Quote# 236172-4

| Bill To: McNeil Company Builders                    | Job Name: Ostronic Cabinets (Rev 9/1/26)                                             |

# CABINETRY DRAWINGS

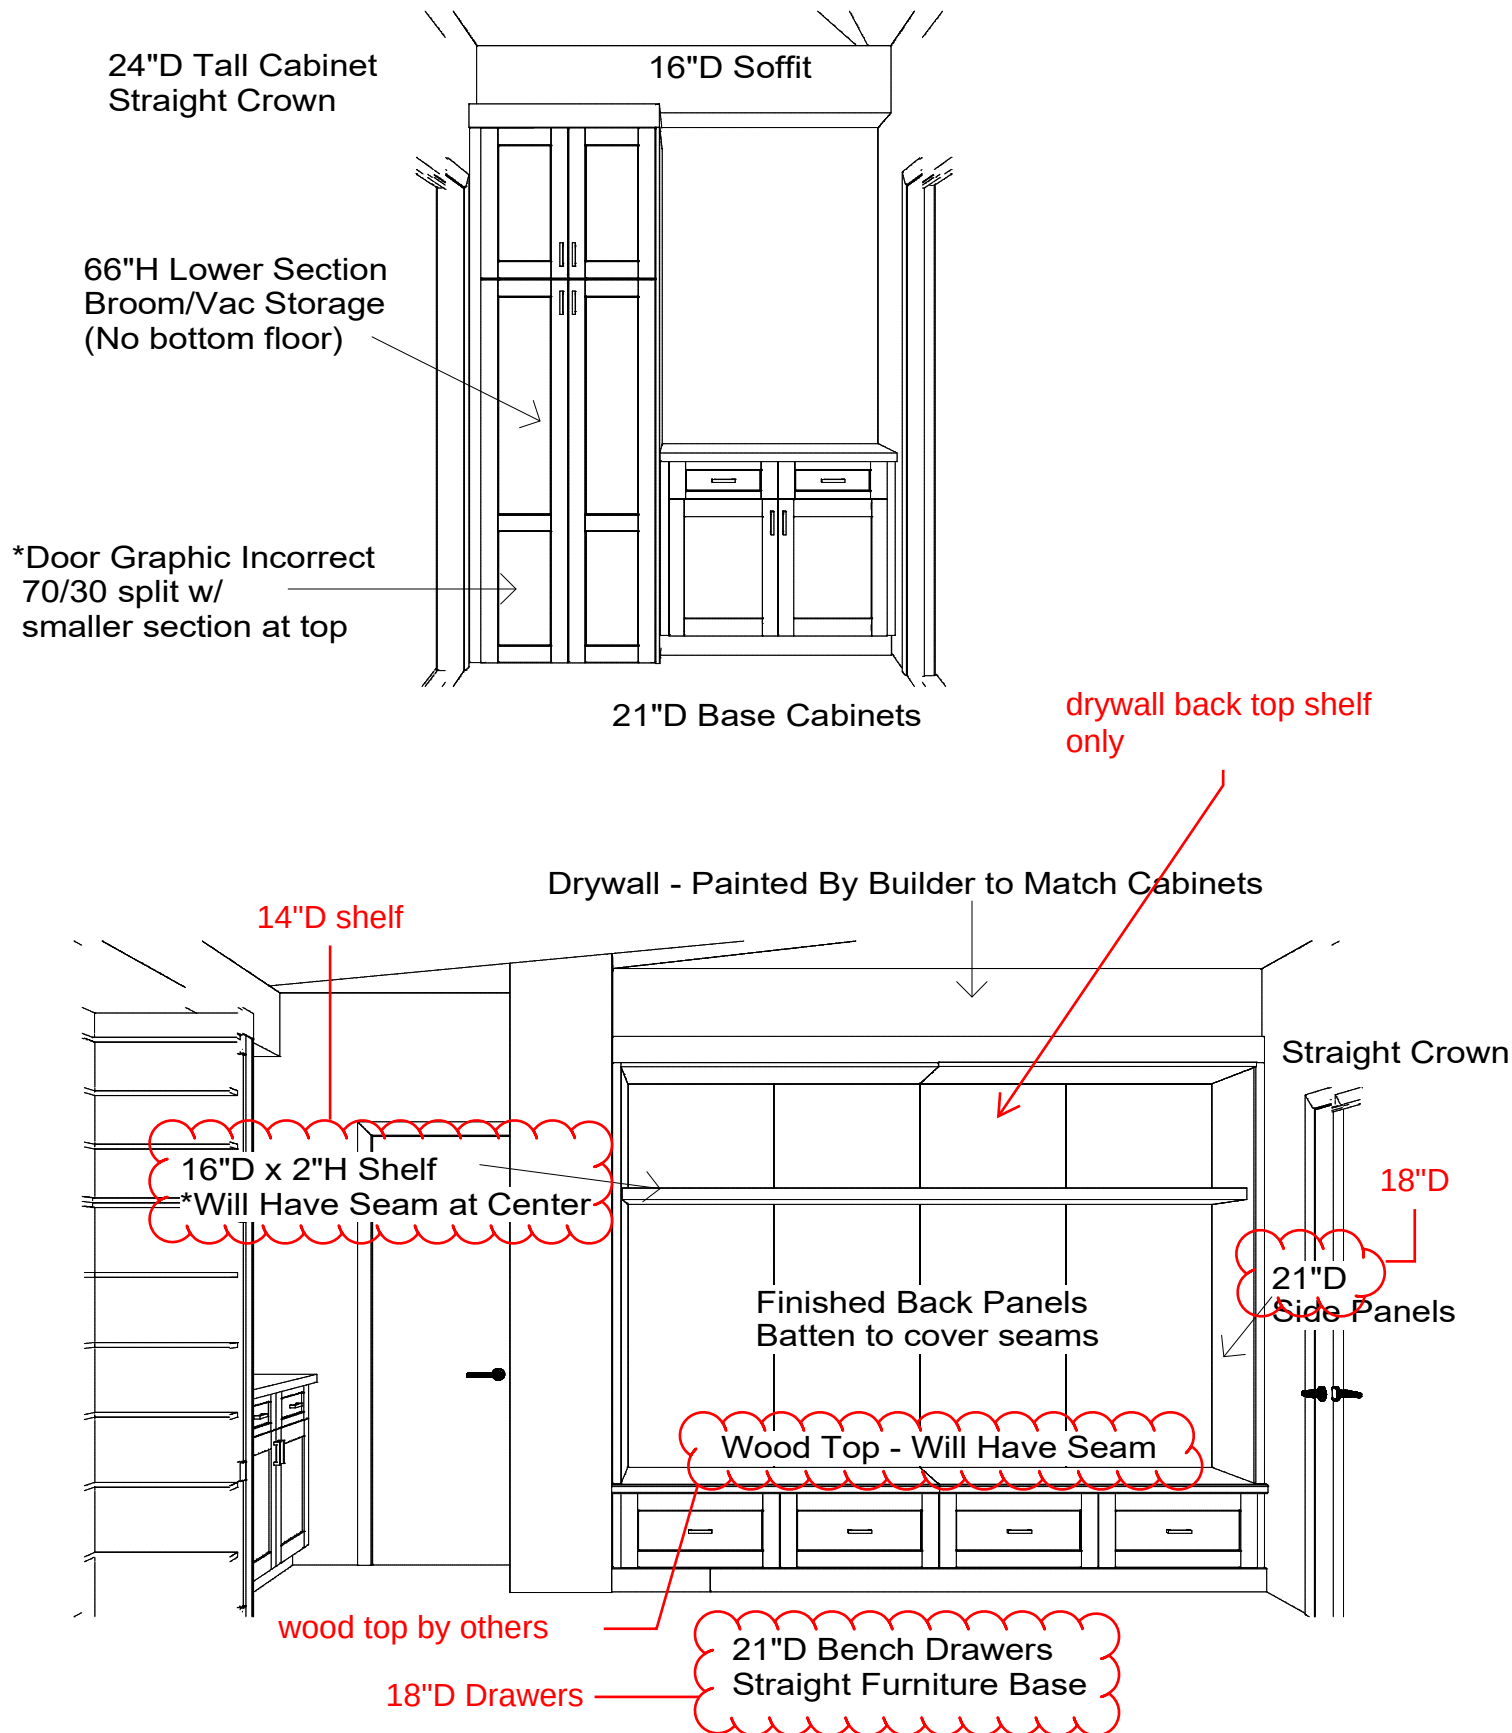
24"D base cabinet, no reeded doors, white oak  
16"D x 2" thick shelves, white oak  
Drywall back  
1 1/2" white oak trim around front of cabinet  
Wood top to be proud of face of door fronts

Room: Office

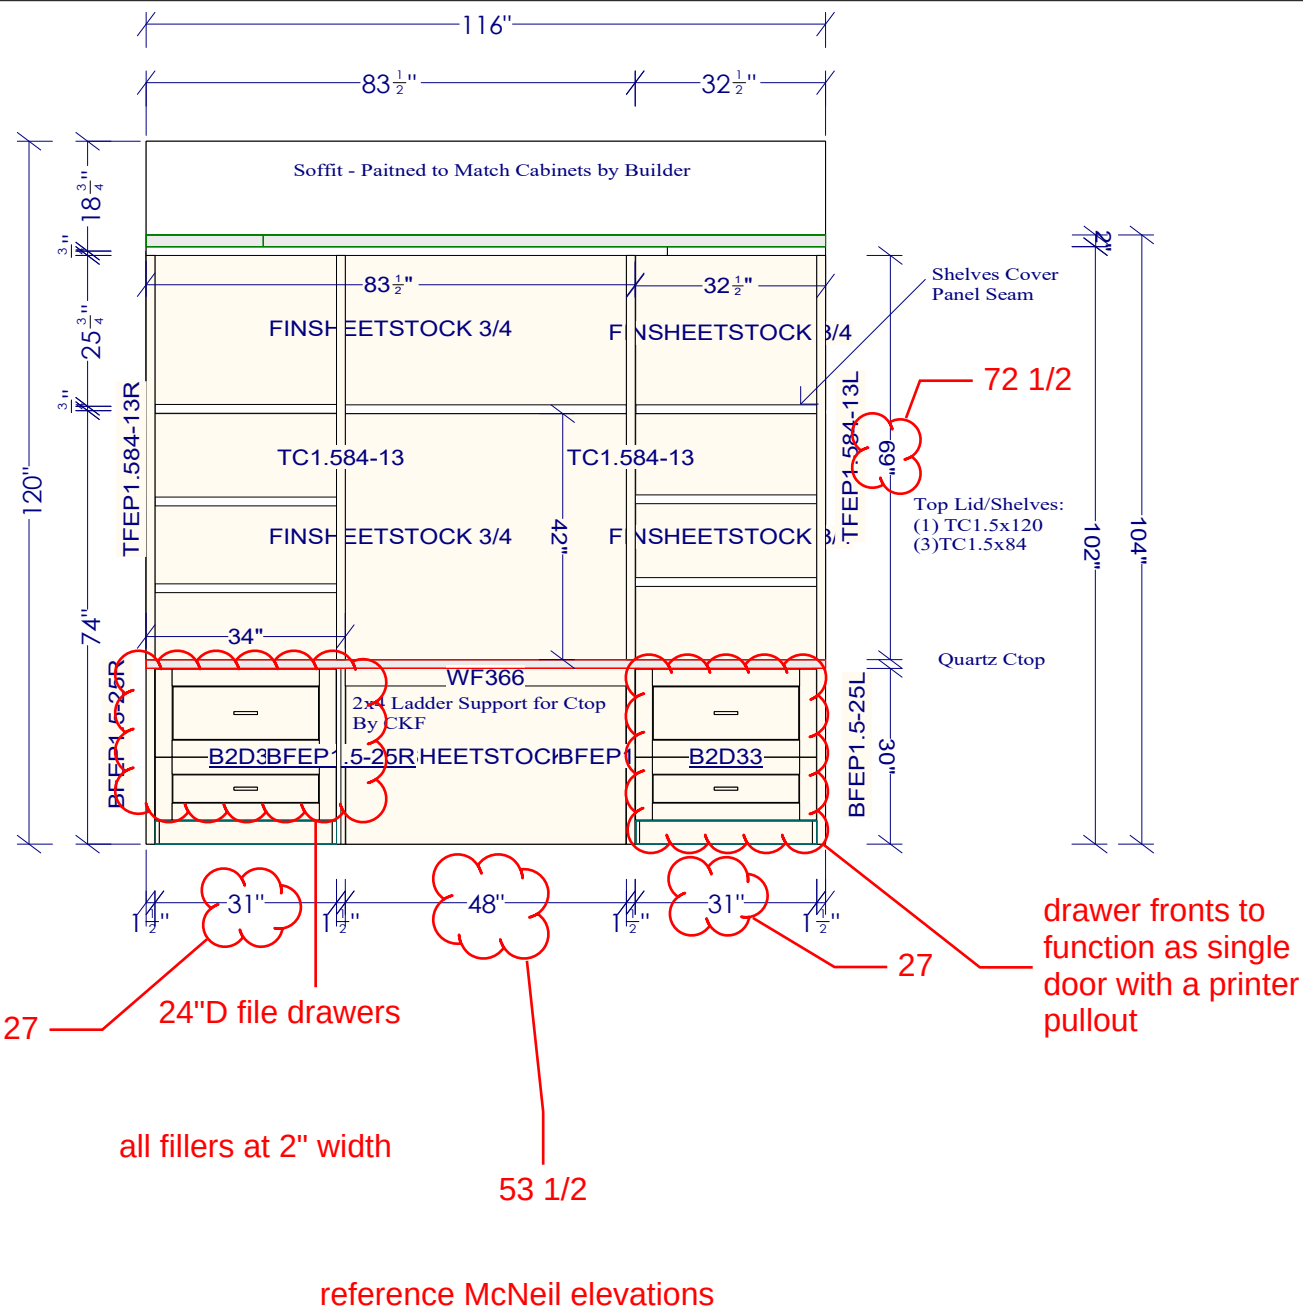
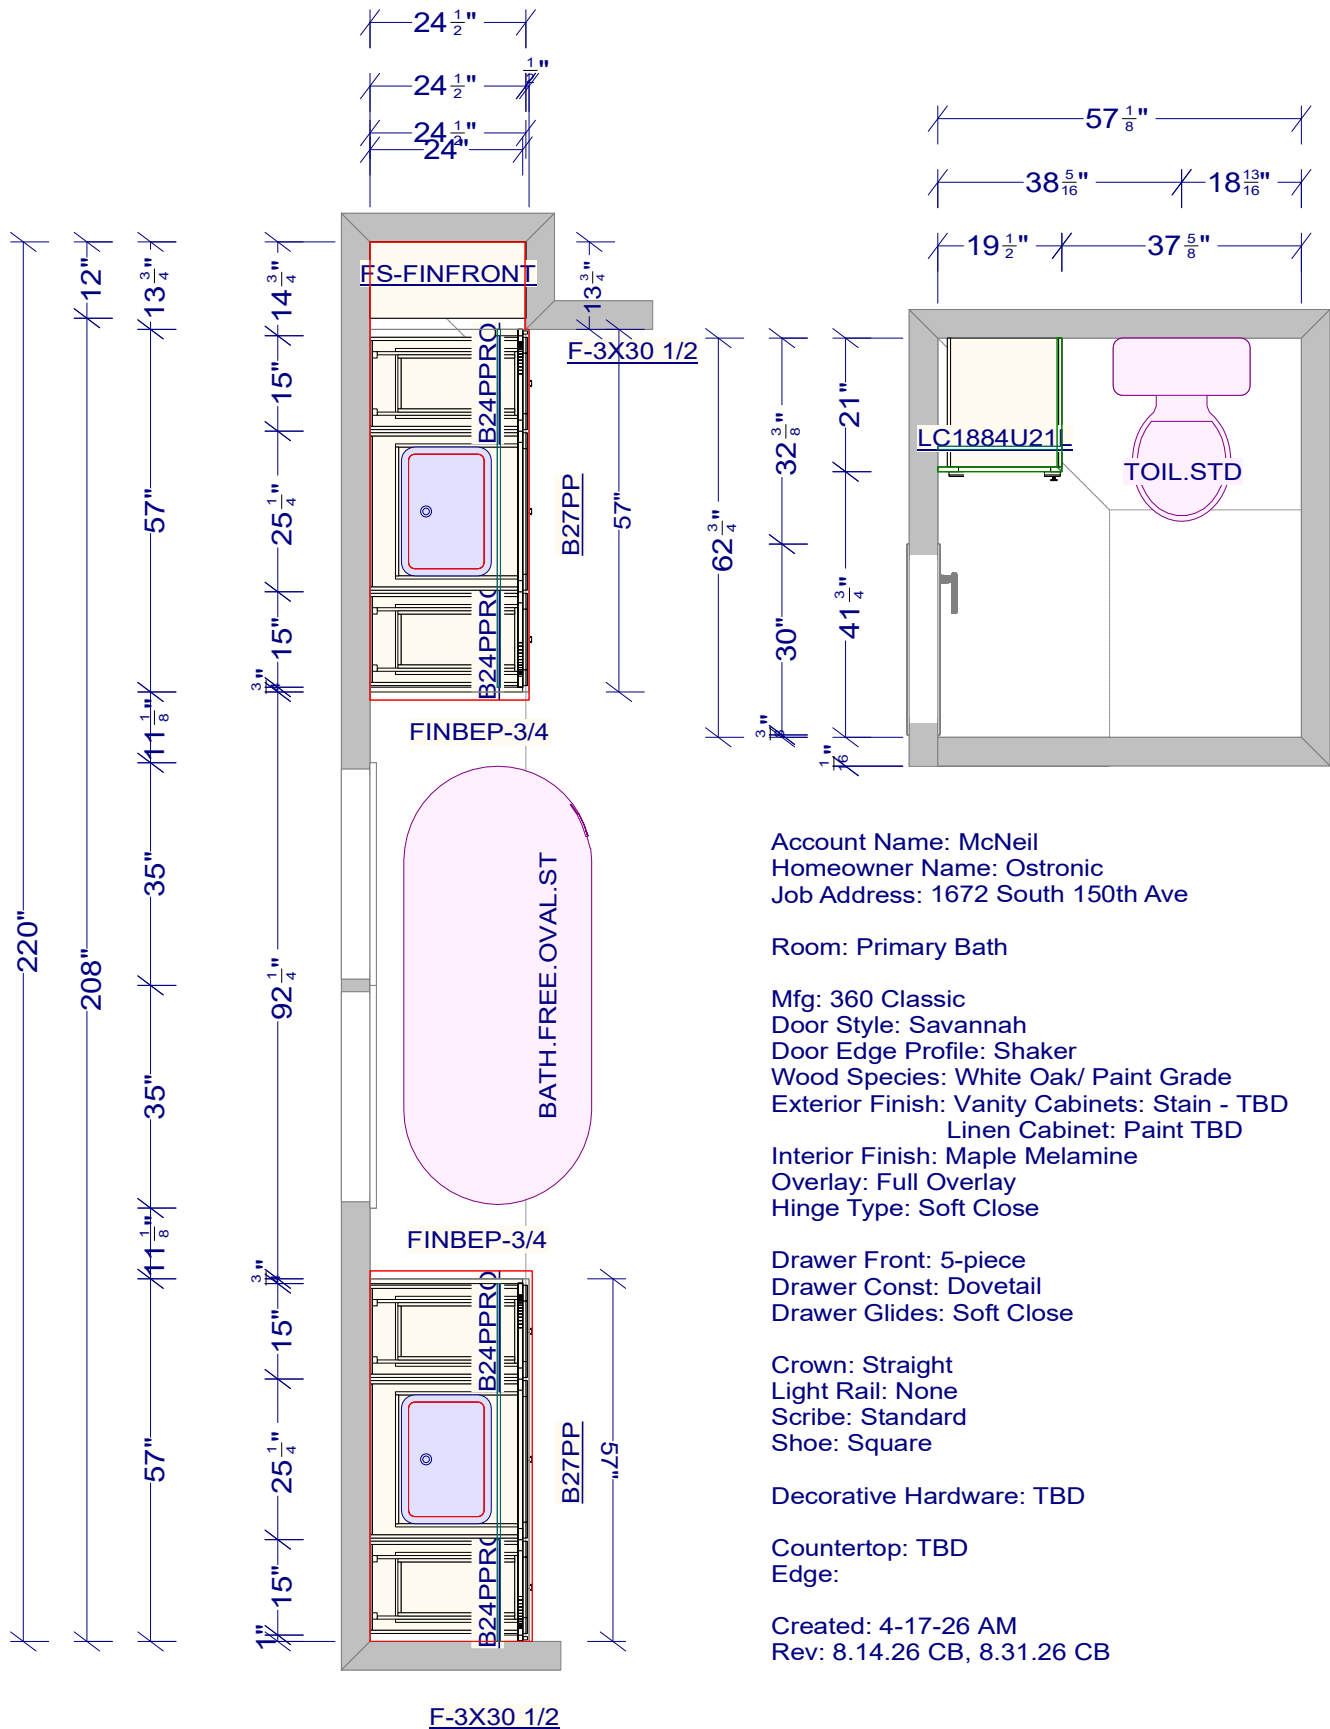
reference McNeil elevations

Room: Bath 3

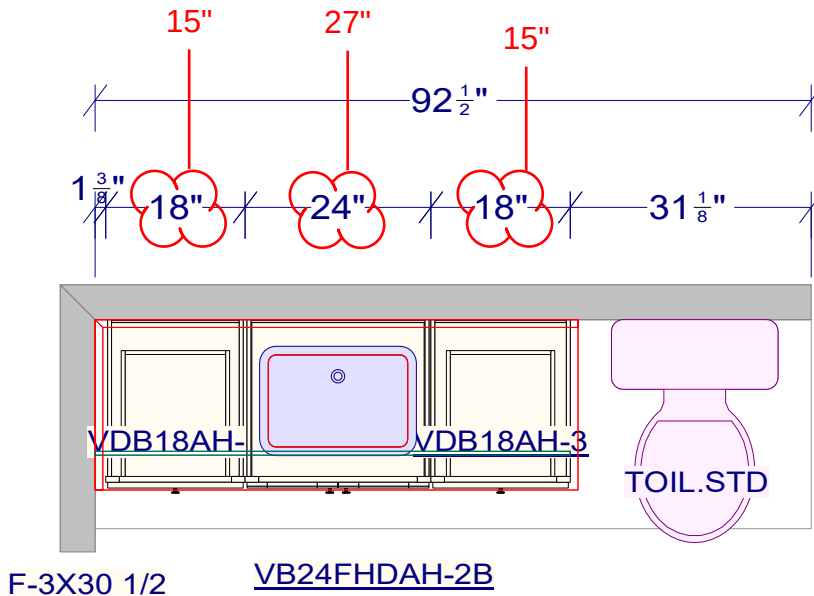
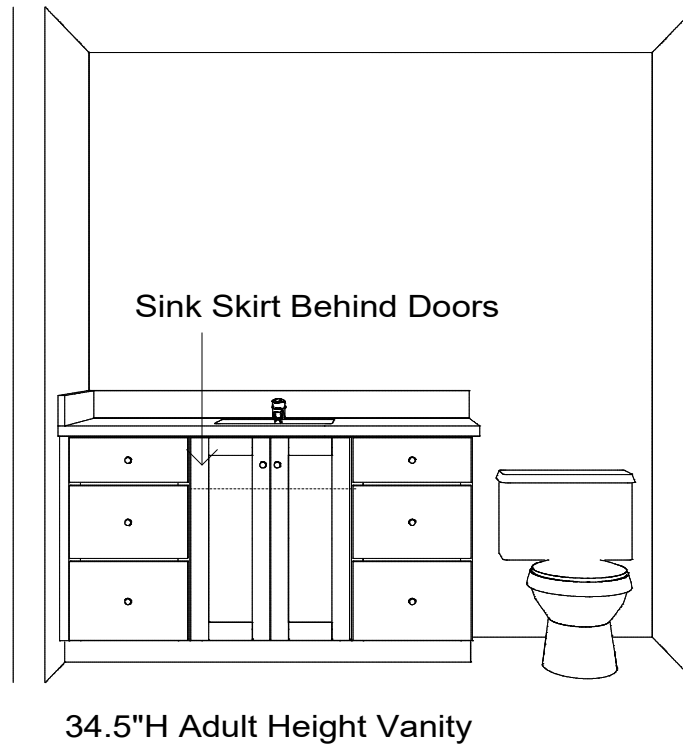
confirm 21"D
